DEVELOPMENT APPLICATION ASSESSMENT REPORT

Application Number:	DA2025/0229
----------------------------	-------------

Responsible Officer:	Nick England
Land to be developed (Address):	Lot 44 DP 207049, 19 Wandearah Avenue AVALON BEACH NSW 2107
Proposed Development:	Alterations and additions to a dwelling house including a swimming pool
Zoning:	C4 Environmental Living
Development Permissible:	Yes
Existing Use Rights:	No
Consent Authority:	Northern Beaches Council
Land and Environment Court Action:	No
Applicant:	ARCLab Pty Ltd

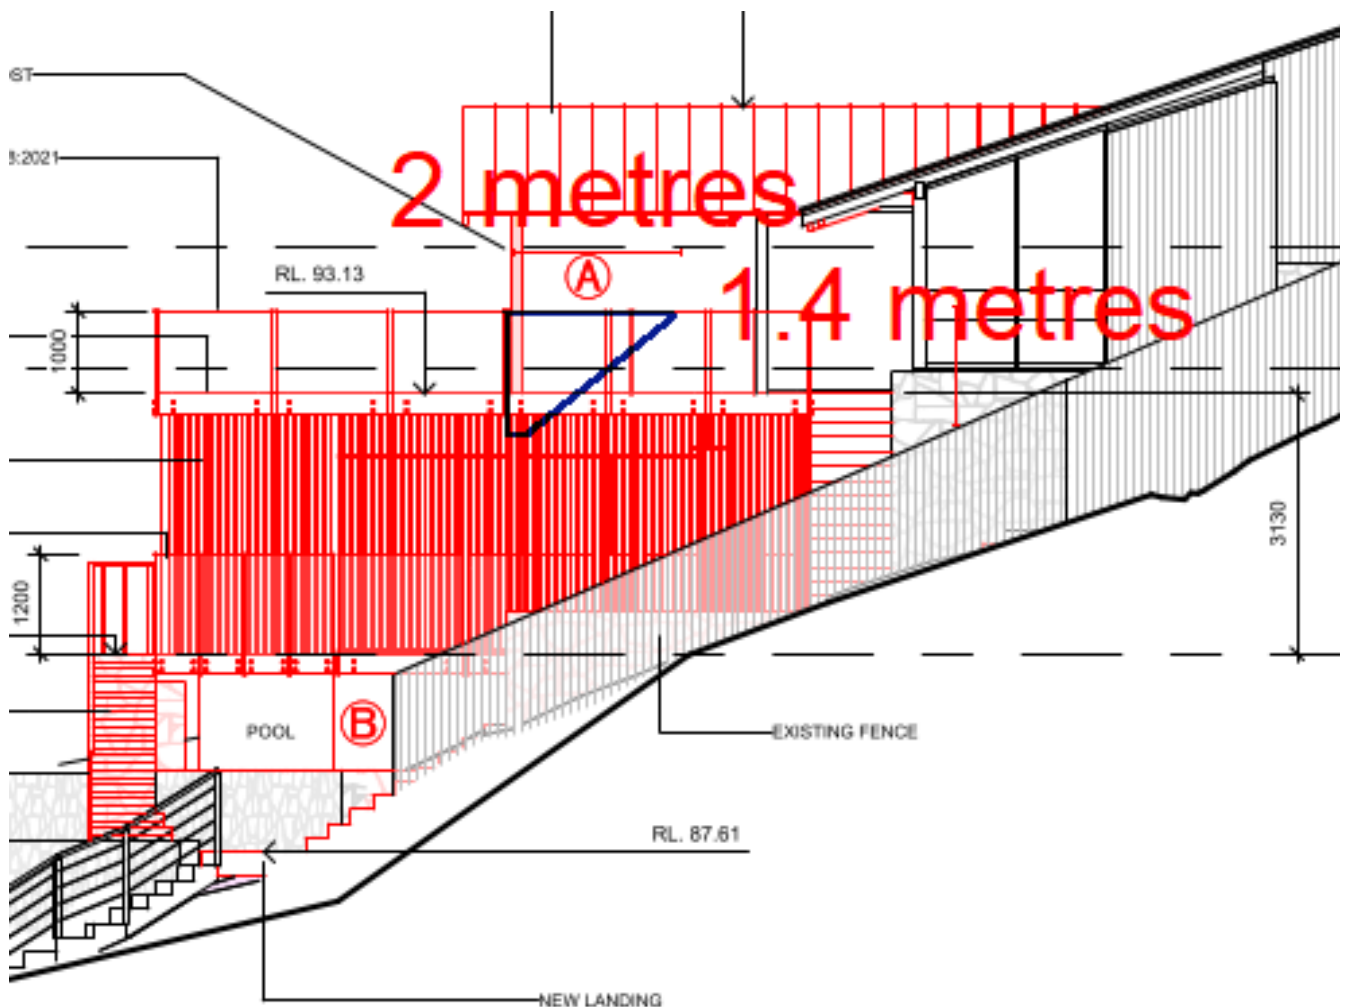
A breach on the west envelope has been identified as being approximately 2m in length and 1.4m in height, representing a 34% variation with the envelope on the horizontal axis. An estimate of the breach is provided below (see area in blue):

Comment: The breach relates to a section of balustrade that is clear glass. Hence, the bulk and scale is minimised.
